Request for a Fence Exemption to the Toronto Municipal Code, Chapter 447 - 101 Drewry Avenue

Date: May 26, 2026

To: North York Community Council

This report responds to an application submitted by the property owner of 101 Drewry Avenue requesting approval for a site-specific Fence Exemption under Section 447-1.2B (1), Section 447-1.2C (1) of Toronto Municipal Code Chapter 447 – Fences.

Attachment 2: East full view of the sidewalk showing the concrete cinder block wall and pillars. Photograph taken by Officer - 101 Drewry Avenue - City of Toronto.

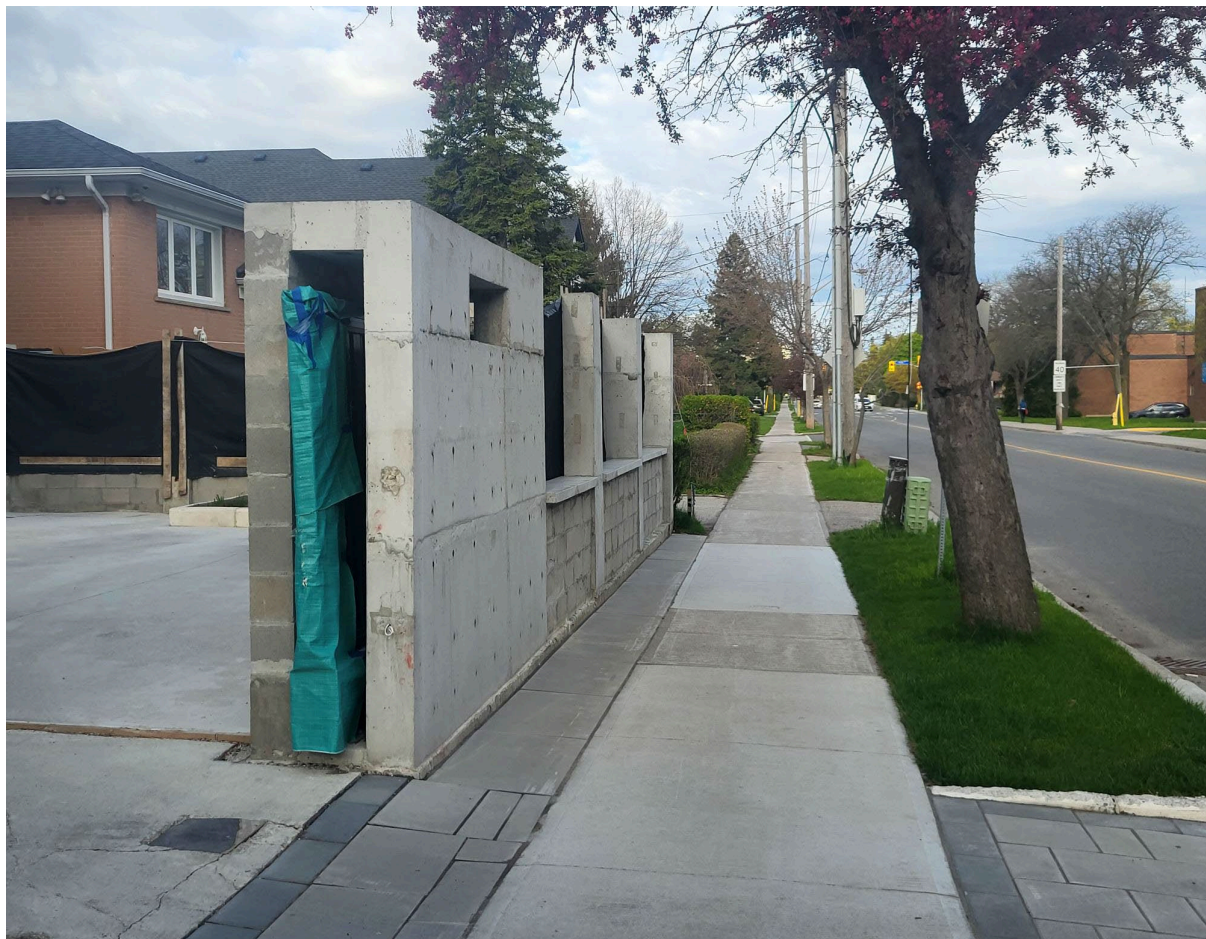
East Front Fence Section: Existing masonry wall measuring approximately 1.0 metres in height with proposed wrought iron fencing above measuring approximately 1.2 metres in height, resulting in a combined fence height of approximately 2.2 metres. The combined height exceeds the maximum permitted height of 1.2 metres by approximately 1.0 metres.

East Front Fence Section, consisting of existing concrete cinder block walls and concrete piers (columns) located within 2.4 metres of the driveway area, does not constitute an open mesh chain-link fence or equivalent open-fence construction as required under Toronto Municipal Code Chapter 447-1.2C (1)– Fences.

The solid concrete cinder block and pillar construction, together with the proposed wrought iron fence and gates, contributes to an overall fence height exceeding the maximum permitted height and does not satisfy the required open-construction visibility provisions adjacent to the driveway areas.

1. Refuse to grant the application for exemption by the owner of 101 Drewry Avenue as the current and proposed fence does not comply with the provisions of Toronto Municipal Code Chapter 447 – Fences.

Attachment 5: East interior view of pillars and proposed housing for gate. Photograph taken by Officer - 101 Drewry Avenue - City of Toronto.

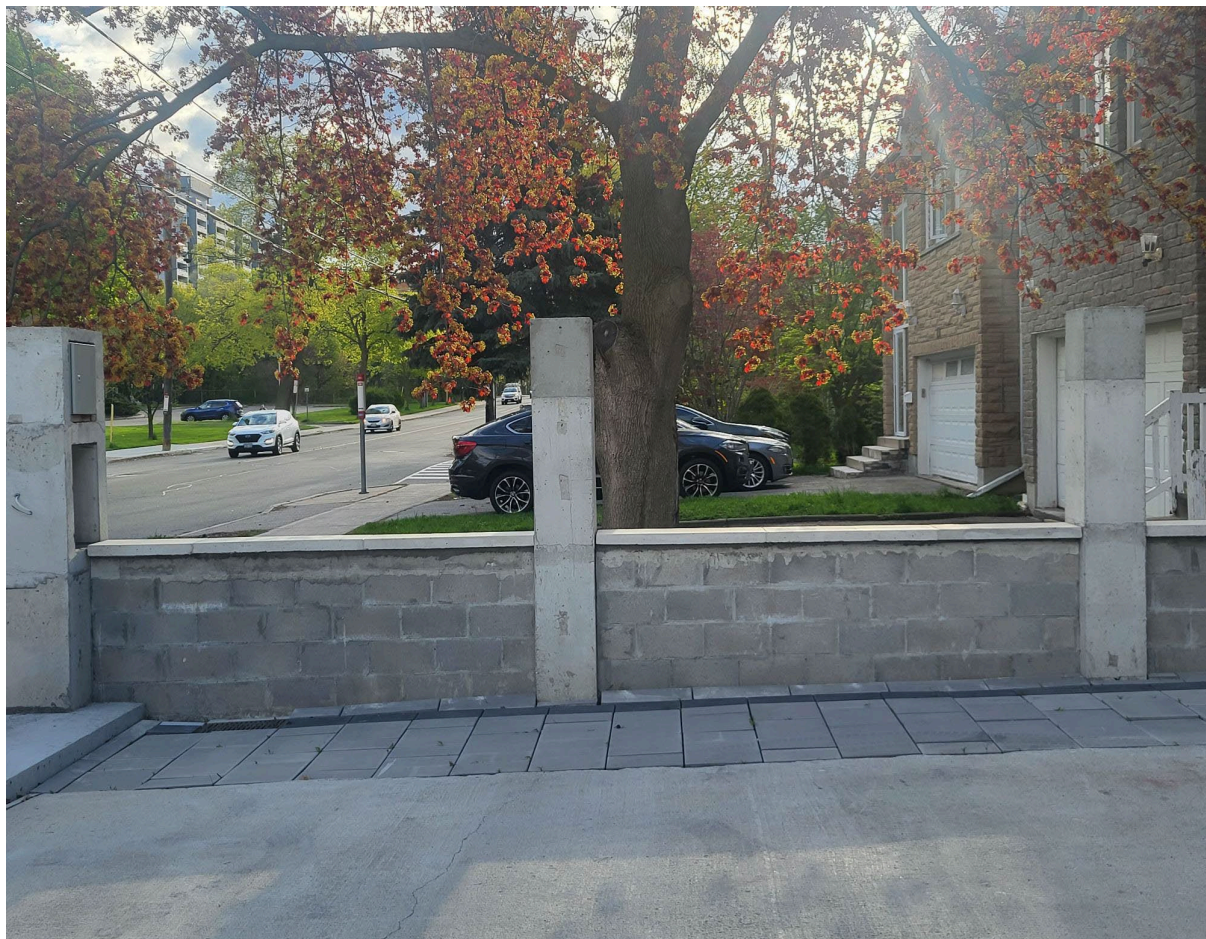
Proposed East Front Fence Section: Existing masonry wall measuring approximately 1.0 metres in height with a proposed addition of wrought iron fencing measuring approximately 1.2 metres in height above the existing wall, resulting in a combined proposed fence height of approximately 2.2 metres. The proposed addition would increase the overall fence height beyond the maximum permitted height

Attachment 8: West view of the sidewalk, concrete cinder blocks, and pillars.
Photograph taken by Officer -101 Drewry Avenue - City of Toronto.

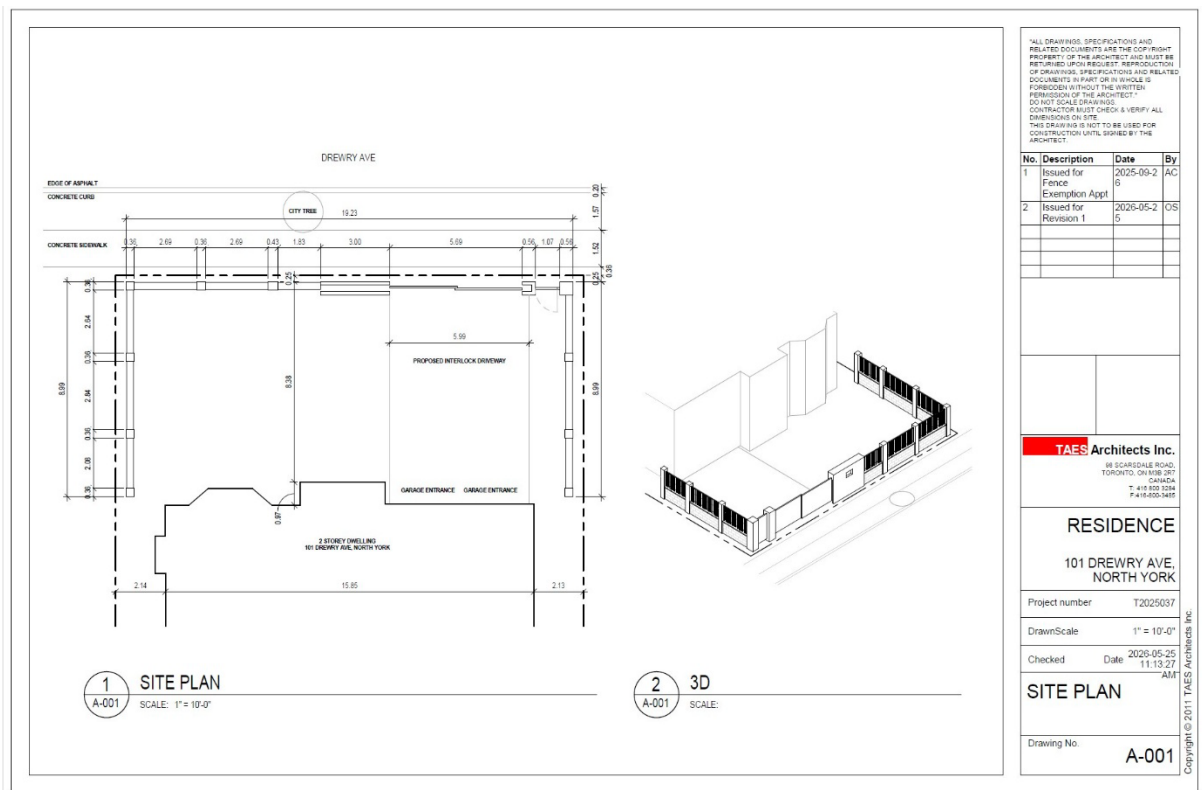
West Front Fence Section: Existing masonry wall measuring approximately 1.0 metres in height with proposed wrought iron fencing above measuring approximately 1.2 metres in height, resulting in a combined fence height of approximately 2.2 metres. The combined height exceeds the maximum permitted height of 1.2 metres by approximately 1.0 metres.

West Front Fence Section, consisting of existing concrete cinder block walls and concrete piers (columns) located within 2.4 metres of the driveway area, does not constitute an open mesh chain-link fence or equivalent open-fence construction as required under Toronto Municipal Code Chapter 447-1.2C (1)– Fences.
